Comment
responses are in
magenta.

Falcon Highlands South

Preliminary Drainage Report

PUDSP-22-005

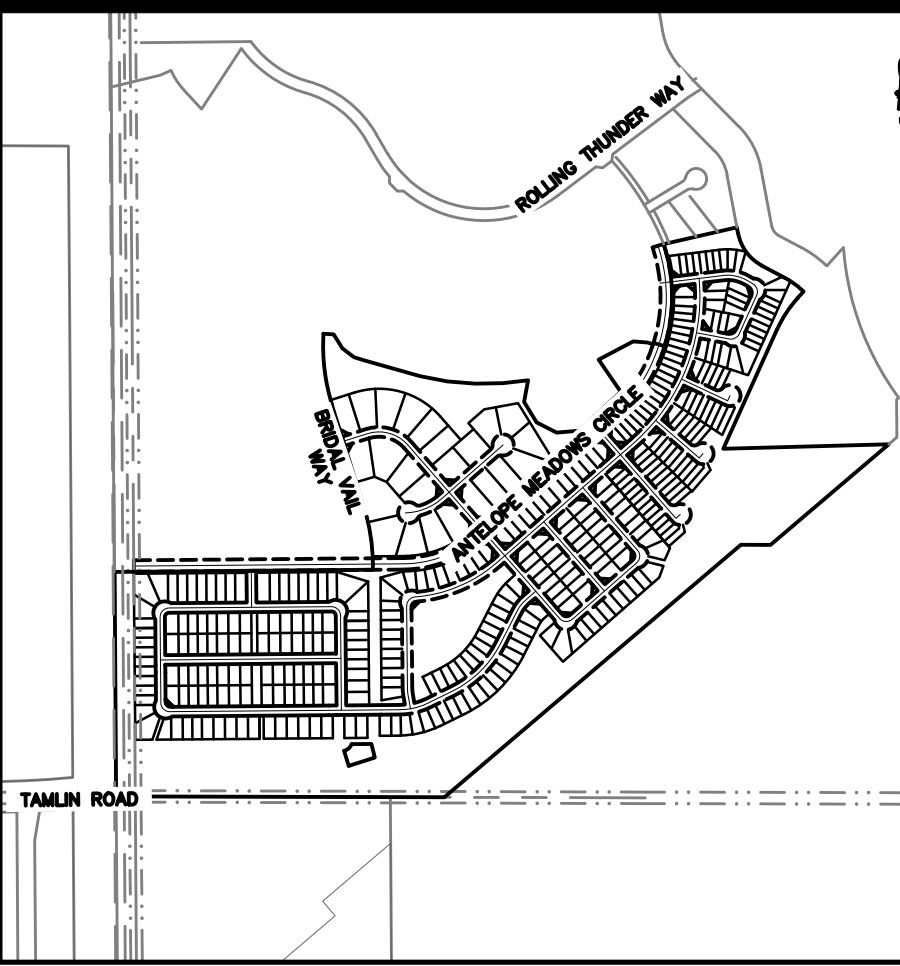
limit the RPA area so that you dont have to maintain the entire tract

are these lots just flowing into the pond? if so, you dont need runoff reduction calcs

The RPA area is pervious area: 2.9 AC. OF UNDEVELOPED PRAIRIE/GREENBELT now shown smaller.

This area is flowing directly into the pond and the impervious area has been updated.

This area now drains into a swale and into the storm system and ultimately into the pond. This impervious basin area has been removed.
